**NSLPP MEETING HELD ON 03/04/24****Attachments:**

ADDRESS/WARD: 54 High Street, North Sydney**APPLICATION No:** D206/23**PROPOSAL:** Construction of a sunroom, deck and balustrades for an existing apartment on the 9th floor and modifications to various conditions in Development Consent 105/22.**PLANS REF:**

OWNER: SP8461. SP55509**APPLICANT:** Joseph Georghy**AUTHOR:** Robin Tse, Senior Assessment Officer**DATE OF REPORT:** 25 March 2024**DATE LODGED:** 10 July 2023**RECOMMENDATION:** Approval (Deferred Commencement)

Figure 7: Ladder and access Door to the roof top located within the existing stairwell (Common Property)

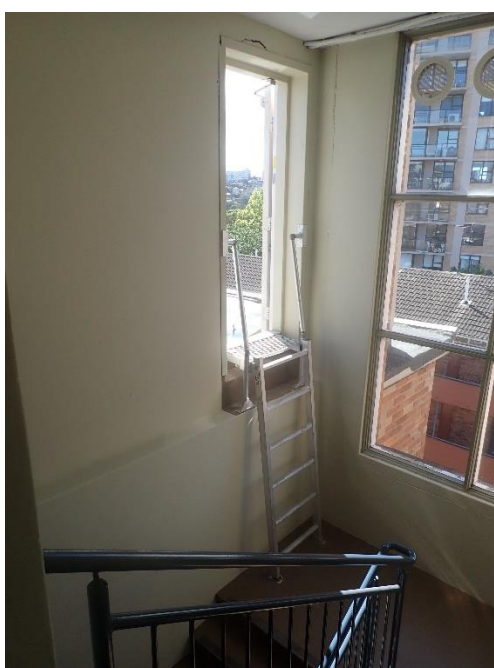
The applicant considers that service/maintenance access is already adequately provided via a ladder and the access door within the existing stairwell (**Figure 7**).

The applicant considers that service/maintenance access is already adequately provided via a ladder and the access door within the existing stairwell (**Figure 7**).

12. The applicant and/or the owner of the subject property, shall provide access through the subject exclusive use area on the 9th floor to the external roof areas to carry out maintenance and repair works by qualified/authorised persons in accordance with the provisions of the By-Laws relevant to the subject studio apartment on the 9th floor.

It is considered that any provision for maintenance/service access to the external roof areas on the 9th floor must be consistent with the provisions of the relevant By-Law. It is therefore recommended that the wording of **Condition I2** in **DA105/22** be modified as detailed earlier in this report.

**Figure 10: View from the living room balcony of Unit 3D at No. 50 Whaling Road
(Source: Domain.com)**

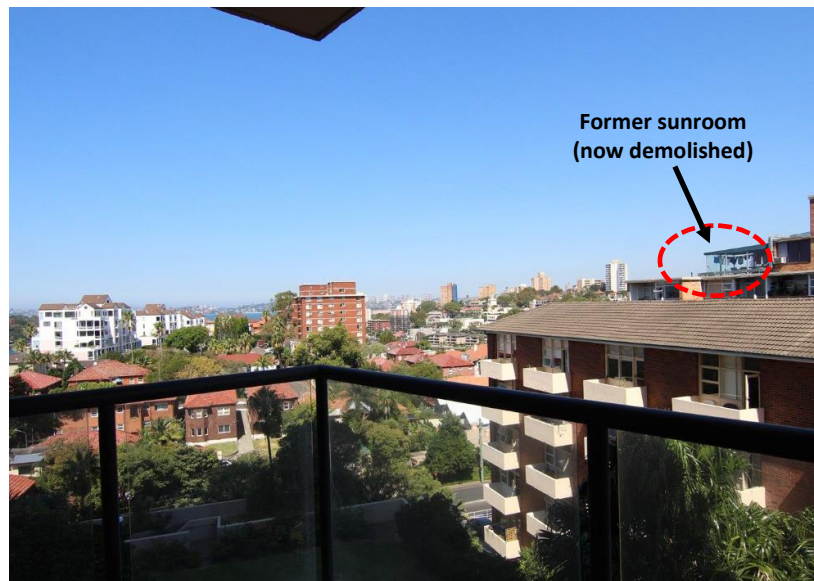
An examination of publicly available photographs taken from Unit 3D and Unit 5D on the 3rd and 5th floors within No.50 Whaling Road have revealed that the proposal is unlikely to have material impacts on significant views as seen from these nearby apartments. It is because the proposed sunroom would only affect a small part of the view to the sky as seen from the 3rd floor apartment (**Figure 10**) and district views with vegetation/buildings as seen from the 5th floor apartment (**Figure 11**). In addition, the harbour views as seen from the two apartments towards the south-east would be retained and not affected by the proposal.

It is also noted that the two photos featured the former sunroom (now demolished), constructed under CDC, at a similar location as the proposed sunroom.
